CAP Meeting Agenda

ITEM 4.1**DEVELOPMENT APPLICATION – 24038446 – 5 CEDAR AVENUE, UNLEY PARK**

DEVELOPMENT NO.:	24038446
APPLICANT:	Urban Habitats Pty. Ltd.
ADDRESS:	5 CEDAR AV UNLEY PARK SA 5061
NATURE OF DEVELOPMENT:	Demolition of existing ancillary structures, partial demolition of the existing dwelling, construction of dwelling additions and alterations (including a cellar, garage and terrace), an in-ground swimming pool with associated pool safety fencing and equipment, boundary fencing (including masonry fencing exceeding a height of 1 metre) and underground rainwater tank
ZONING INFORMATION:	<p>Zones:</p> <ul style="list-style-type: none"> • Established Neighbourhood <p>Overlays:</p> <ul style="list-style-type: none"> • Airport Building Heights (Regulated) • Building Near Airfields • Historic Area • Prescribed Wells Area • Regulated and Significant Tree • Stormwater Management • Urban Tree Canopy <p>Technical Numeric Variations (TNVs):</p> <ul style="list-style-type: none"> • Maximum Building Height (Metres) (Maximum building height is 6m) • Minimum Frontage (Minimum frontage for a detached dwelling is 20m) • Minimum Site Area (Minimum site area for a detached dwelling is

Figure 15: Proposed eastern boundary wall

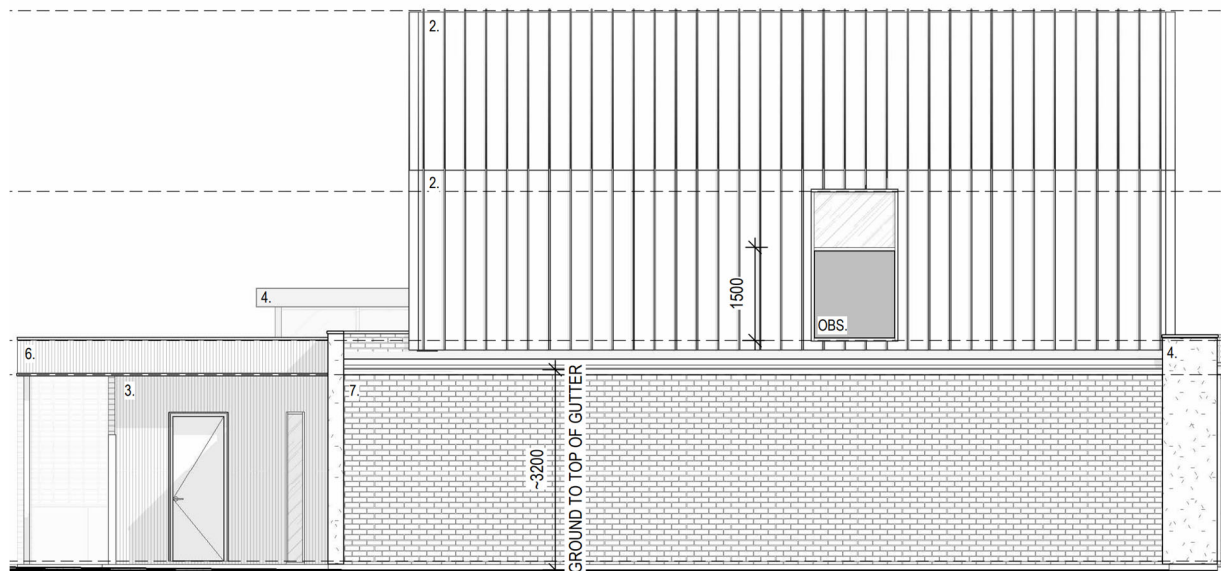
As referenced in DPF 7.1, the first building level of dwellings are to be setback 2 metres from a side boundary and the second building level is to be setback 4 metres. We also note that boundary walls are to be limited in height and length to manage visual impacts.

The boundary wall will represent a dominant visual element when viewed from our client's rear yard given the length of over 14 metres and height of 3.2 metres. Further, the visual dominance of the boundary wall will be exacerbated by the visual impact of the featureless second level wall and roof line above the boundary development which extends for a length of 12 metres and additional height of 5.31 metres, as is evident in the following figure:

- Whilst Representor 1 asserts that no boundary development of this scale exists in the area, it is important to keep in mind that the wall in question is replacing an existing wall that is 1.0 metre longer, only 40 centimetres off the boundary (see Figure 2 overleaf) and at odds with the National Construction Code, thereby resulting in the creation of a vermin trap. It is also worth noting that the eastern wall of the existing structure was visible from Representor 1’s property until four years ago, when the Applicant installed a good neighbour fence to prevent dirt and water from accumulating and flooding the structure’s cellar. Prior to that, the eastern wall effectively served as a boundary wall. Relocating the garage onto the boundary will resolve these issues.

- Whilst PO 7.1 of the EN Zone refers to the setback of boundary walls being 2.0 metres from side boundaries, it is important to note that the relevant Historic Area Statement (**HAS**), in this case, Residential Spacious Unley Park (West) Historic Area Statement (Un24), which prevails over the EN Zone policies, states that *“Carports, garages and side additions are separate and recessed from the main building and façade, and are a minor, unobtrusive presence in the streetscape.”* As detailed within the Building Height and Streetscape Appearance Section of this response, the proposed addition achieves this on account of its extensive setback from the primary street, its overall height relative to the existing building and neighbouring dwellings, and its obscurity as viewed from the public realm.

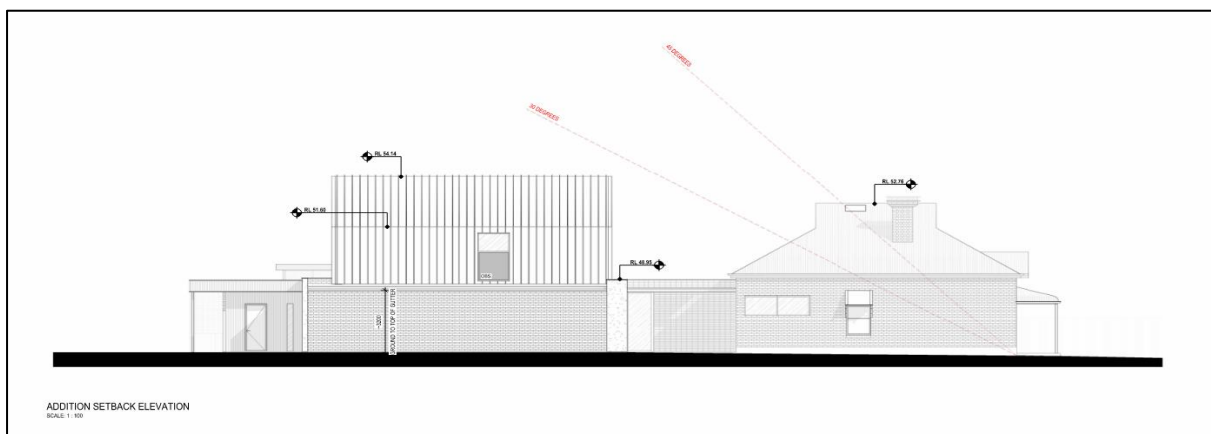
PO 3.1 *Alterations and additions complement the subject building, employ a contextual design approach and are sited to ensure they do not dominate the primary façade.*

PO 3.2 *Adaptive reuse and revitalisation of buildings to support retention consistent with the Historic Area Statement.*

In relation to PO 3.2 of the HAO, the proposed addition will preserve the original 1915 double-fronted cottage. It is important to note that the primary intent of the HAO is to retain character dwellings, which the proposed addition clearly does.

Figure 6. The proposed development results in minor encroachments for the tree under *Australian Standard AS 4970-2009 Protection of Trees on Development Sites*.

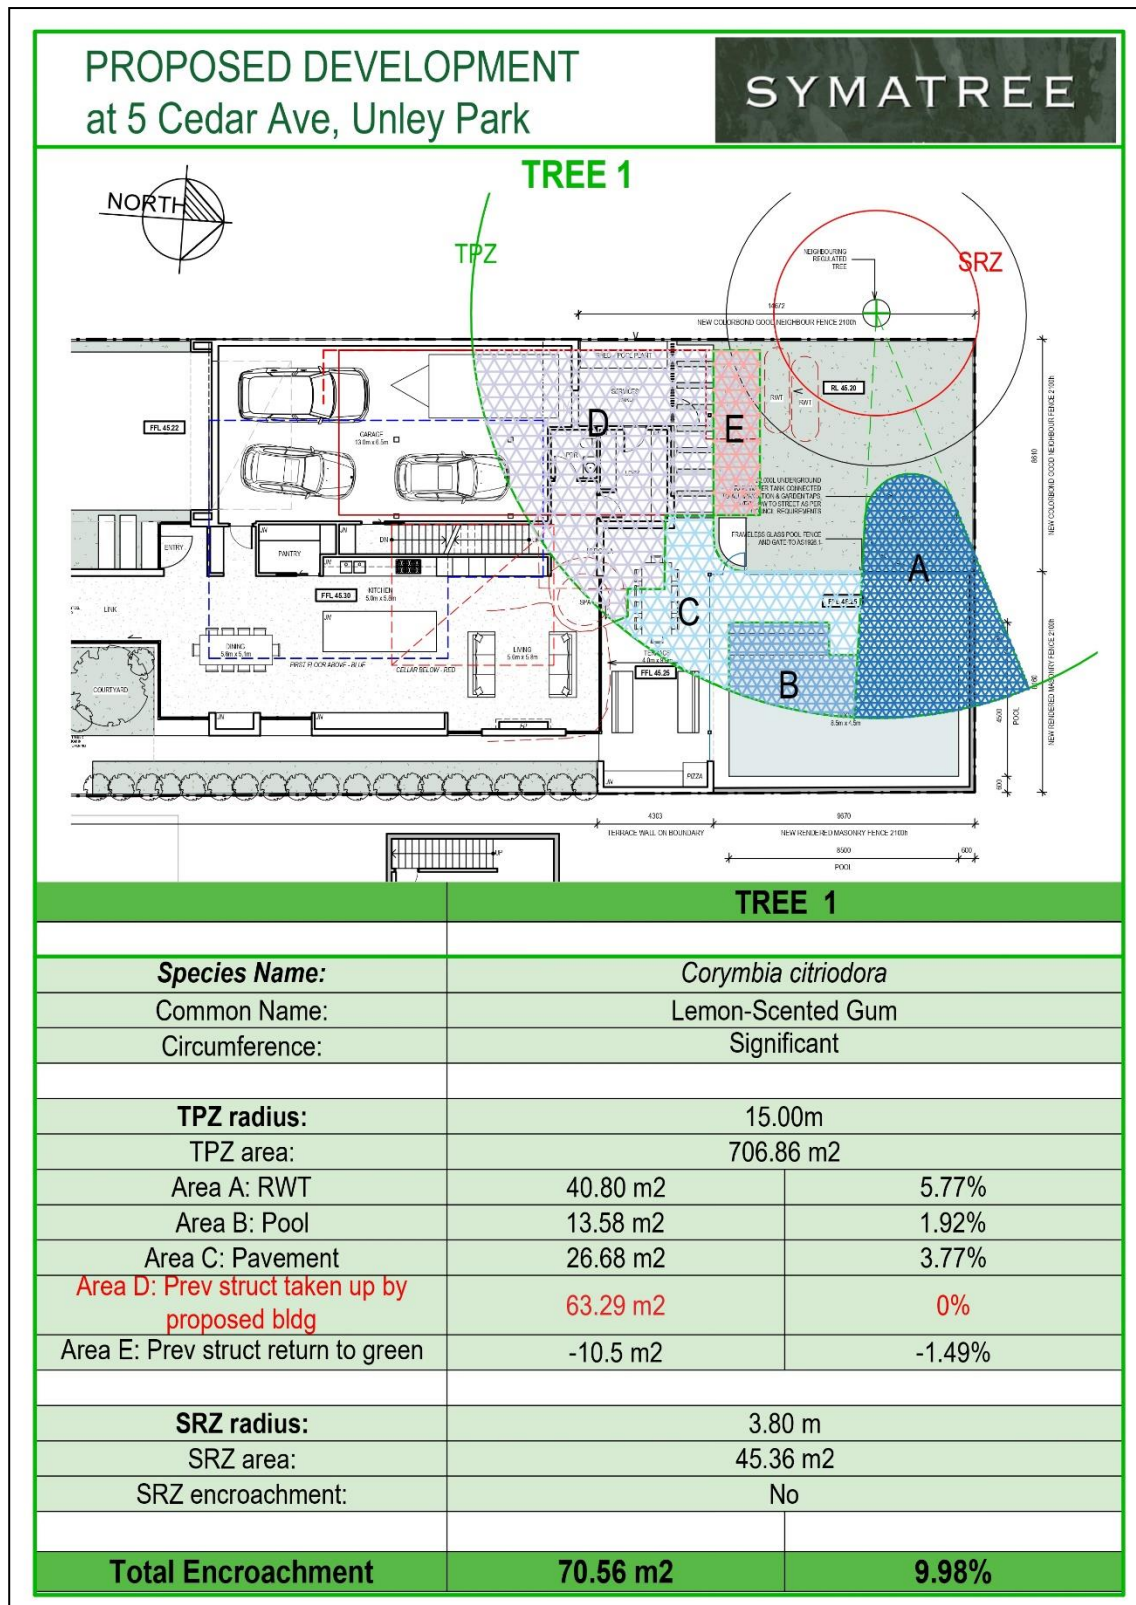
Based on the minor level of encroachment, adverse impacts to the health and stability of the tree are not expected, therefore the proposed development can proceed in a typical format without the need to utilise tree-sensitive designs. Tree protection measures outlined within the Tree Protection Plan of this report will need to be adhered to.

All demolition work that is undertaken within the TPZ of the tree shall be undertaken in a tree-sensitive manner in accordance with the Tree Protection Plan of this report.

The boundary fence has been indicated as being replaced. This will need to occur in a like-for-like format using tree sensitive methods specified within the tree protection plan of this report.
